## TECHNICAL MEMORANDUM

**Re:** **Response to Comments on Special Use Permit Application – Trapper Solar Project  
Application Number PL20240046**

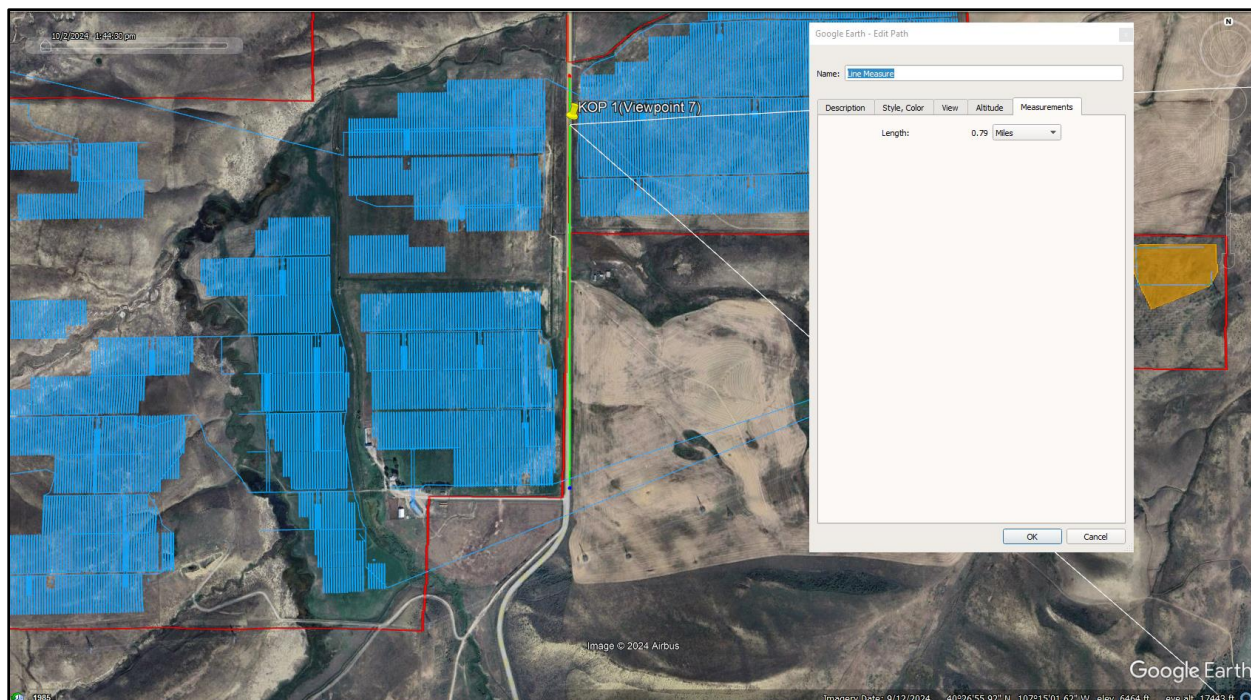
37. This report was prepared using a 15’ panel height. The narrative states that the panels will not exceed 25’. Are there areas where the full 25’ panel height will be used? If so, where will these be?

37. While further design is needed, the Project final design is not anticipated to have panels as high as 25 feet. The maximum height would be 15 feet due to the need to keep panels above the snow, but at this point, the Applicant does not have that level of detail since design is still under way and the Project has not yet received local approval.

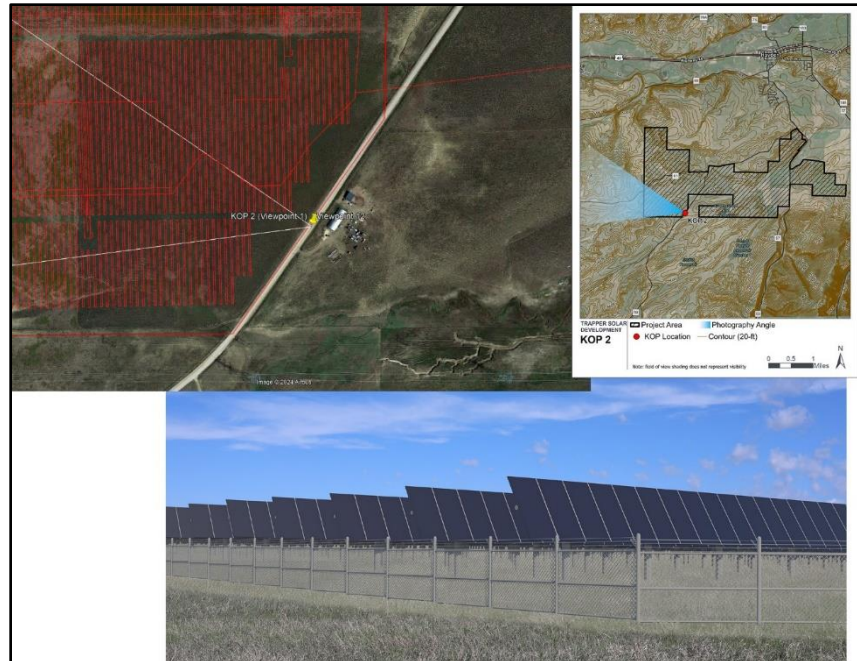
41. The photo simulations don’t seem to represent an accurate view based on the location and direction of view.
- KOP1 – The direction of view on vicinity map is east/southeast. The photo simulations looks directly at the back of the panels. Based on the vicinity map, it should mainly be the side with some of the back will be seen.
  - KOP2 – The direction of view on vicinity map is west/northwest. The photo simulations shows an almost head on view of the panels. Based on the vicinity map, mainly the sides, with some of the front, of the panel will be seen.

- c. KOP4 – The direction of view on vicinity map is southwest. The photo simulations shows an almost head on view of the panels. Based on the vicinity map, mainly the side/back, with some of the front, of the panel will be seen.

41. Based on the comment, we cannot tell or replicate what the reviewer is describing “based on the vicinity map;” however, the 3D modeling is based on the design layout received and is photographed matched based on the field photo points, existing terrain and known landmark features. Moreover, the PV strings are oriented north-south, so most views looking toward the project from roadways where there is direct adjacency would be dominated by the broadside of the components, whether at the back side or panel side, depending on time of day as displayed in the simulations. See screen shots from KOP 1 and KOP 2 (below) showing the orientation of the strings compared to the highway corridors provided herein.
